Drain-Improvement: SPRINGMILL VILLAGES GRAAN - THE CROSSINGS - SECTION 18

## Springmill Villages Drain – The Crossings - Section 1

RE: Springmill Villages Drain-The Crossing Section 1B Arm

The Bond of Letter of Credit from NBD, number S 036573, dated May 26, 1994, in the amount of \$176,200.00, has expired.

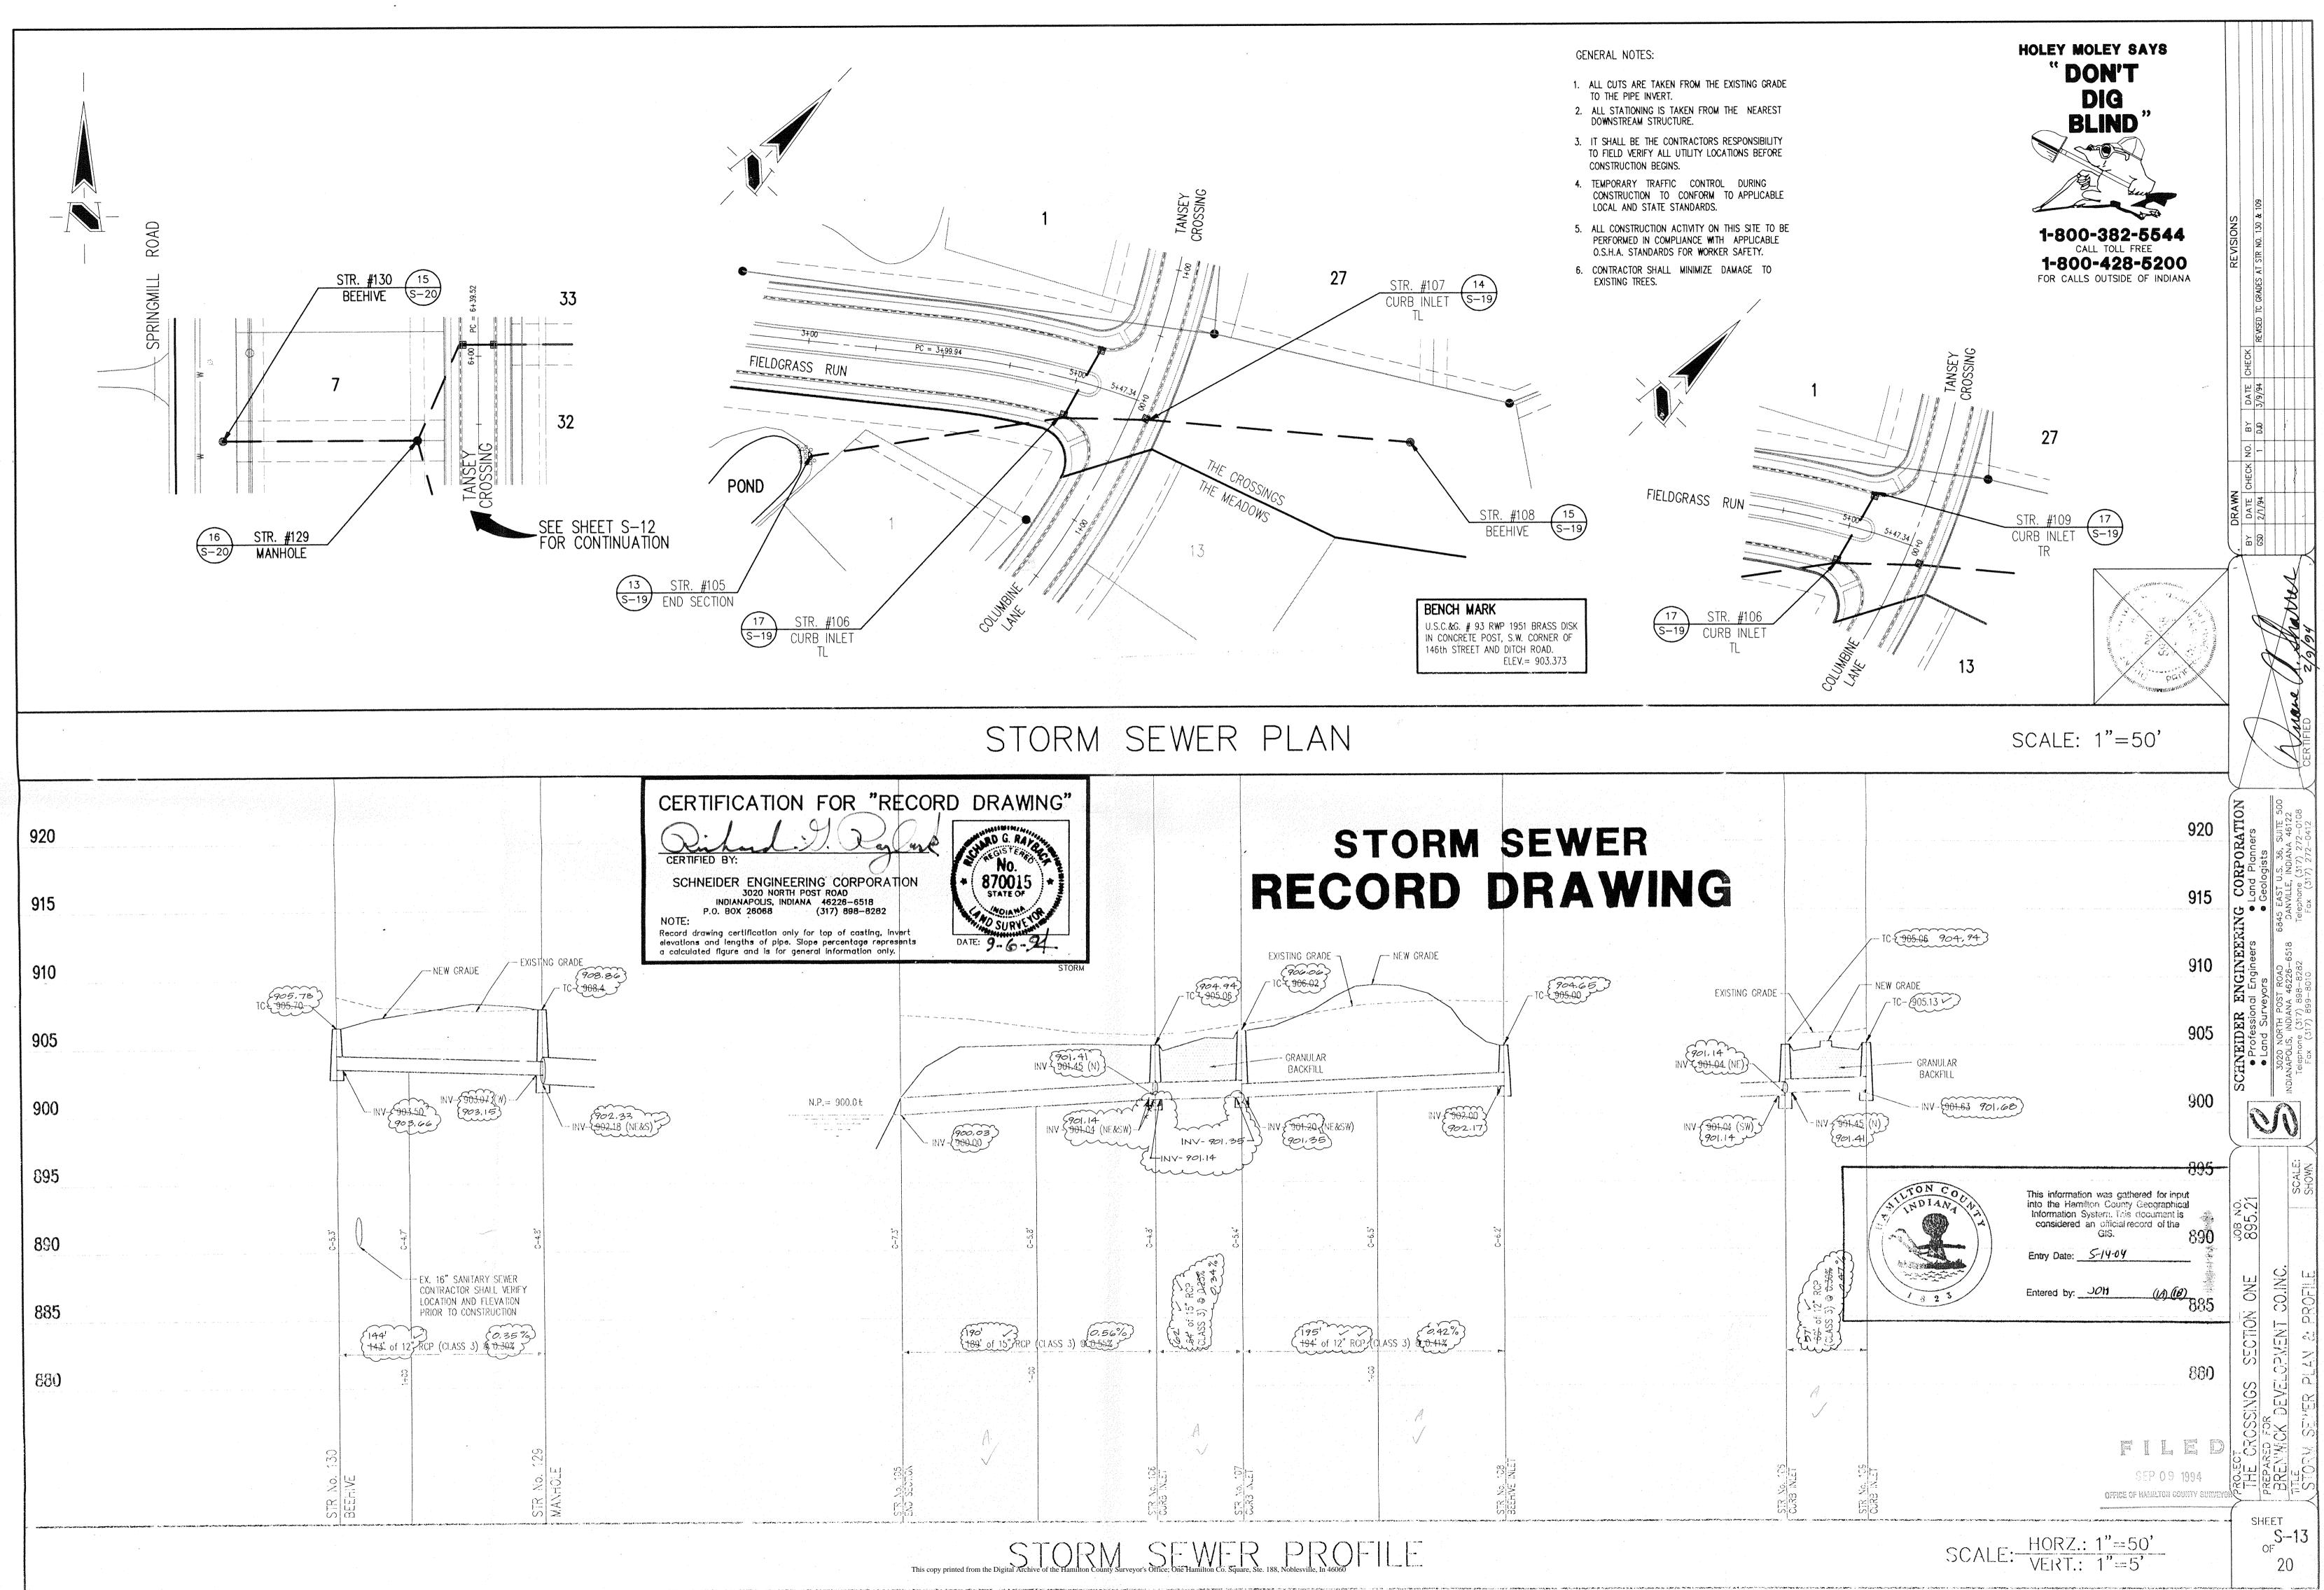
During construction, changes were made to the drain which will alter the plans submitted with my report for this drain dated December: 27, 1994. The changes are as followed:

229 228
STR 131 to 132 24" RCP shortened from 28' to 26 feet STR 132 to 133 18" RCP lengthened from 156' to 160 feet STR 129 to 130 12" RCP lengthened from 143' to 144 feet STR 138 to 137 12" RCP shortened from 28 to 26 feet STR 137 to 136 12" RCP shortened from 178' to 177 feet STR 136 to 139 12" RCP lengthened from 430' to 433 feet STR 139 to 140 12" RCP lengthened from 200 to 203 feet STR 148 to 145 12" RCP shortened from 43' to 41 feet	STR 128 to 129	129 24" RCP	shortened from	149' to 148 feet
STR 132 to 133 18" RCP lengthened from 156' to 160 feet STR 129 to 130 12" RCP lengthened from 143' to 144 feet STR 138 to 137 12" RCP shortened from 28 to 26 feet STR 137 to 136 12" RCP shortened from 178' to 177 feet STR 136 to 139 12" RCP lengthened from 430' to 433 feet STR 139 to 140 12" RCP lengthened from 200 to 203 feet STR 148 to 145 12" RCP shortened from 43' to 41 feet			lengthened from	77' to  78 feet

STR 129 to 130 12" RCP lengthened from 143' to 144 feet STR 138 to 137 12" RCP shortened from 28 to 26 feet STR 137 to 136 12" RCP shortened from 178' to 177 feet STR 136 to 139 12" RCP lengthened from 430' to 433 feet STR 139 to 140 12" RCP lengthened from 200 to 203 feet STR 148 to 145 12" RCP shortened from 43' to 41 feet	STR 131 to 132		shortened from	28' to 26 feet
STR 138 to 137 12" RCP shortened from 28 to 26 feet STR 137 to 136 12" RCP shortened from 178' to 177 feet STR 136 to 139 12" RCP lengthened from 430' to 433 feet STR 139 to 140 12" RCP lengthened from 200 to 203 feet STR 148 to 145 12" RCP shortened from 43' to 41 feet			lengthened from	156' to 160 feet
STR 137 to 136 12" RCP shortened from 178' to 177 feet STR 136 to 139 12" RCP lengthened from 430' to 433 feet STR 139 to 140 12" RCP lengthened from 200 to 203 feet STR 148 to 145 12" RCP shortened from 43' to 41 feet			lengthened from	143' to 144 feet $\sim$

STR 136 to 139 12" RCP lengthened from 430' to 433 feet STR 139 to 140 12" RCP lengthened from 200 to 203 feet STR 148 to 145 12" RCP shortened from 43' to 41 feet	STR 138 to 137	137 12" RCP	shortened from	28 to 26 feet $\checkmark$
STR 139 to 140 12" RCP lengthened from 200 to 203 feet STR 148 to 145 12" RCP shortened from 43' to 41 feet	STR 137 to 136	136 12" RCP	shortened from	178' to 177 feet
STR 148 to 145 12" RCP shortened from 43' to 41 feet	STR 136 to 139	139 12" RCP	lengthened from	430' to 433 feet 🖉
	STR 139 to 140	140 12" RCP	lengthened from	200 to 203 feet $\sim$
COND 147 to 146 108 DOD chembered from 401 to 40 fact /	STR 148 to 145	145 12" RCP	shortened from	43' to 41 feet
SIR 147 to 140 12" RCP SNORTENED IROM 42' to 40 feet	STR 147 to 146	146 12" RCP	shortened from	42' to 40 feet
STR 146 to 145 12" RCP shortened from 43' to 40 feet $\checkmark$	STR 146 to 145		shortened from	43' to 40 feet $ee$

STR 145 to 144	144 12" RCP	shortened from	
STR 144 to 143 12" RCP shortened from 178' to 177 feet $\checkmark$	STR 144 to 143	143 12" RCP	shortened from	
STR 141 to 142 12" RCP shortened from 142' to 138 feet $\checkmark$	STR 141 to 142	142 12" RCP	shortened from	142' to 138 feet 🗸
STR 143 to 149 12' RCP shortened from 28' to 26 feet $\checkmark$	STR 143 to 149		shortened from	
STR 149 to 150 12" RCP lengthened from 207' to 209 feet	STR 149 to 150	150 12" RCP	lengthened from	207' to 209 feet
STR 151 to 157 24" RCP lengthened from 172' to 173 feet	STR 151 to 157	157 24" RCP	lengthened from	
STR 157 to 158 21" RCP lengthened from 297' to 298 feet			lengthened from	
STR 158 to 159 21" RCP shortened from 88' to 86 feet			shortened from	
STR 159 to 160 21" RCP lengthened from 157' to 158 feet	STR 159 to 160		lengthened from	
STR 160 to 161 15" RCP lengthened from 380' to 383 feet	STR 160 to 161	161 15" RCP	lengthened from	380' to 383 feet

The corrected total of six (6") inch SSD is 4,981 feet

The length of the drain due to the changes described above is now 8,404 feet.
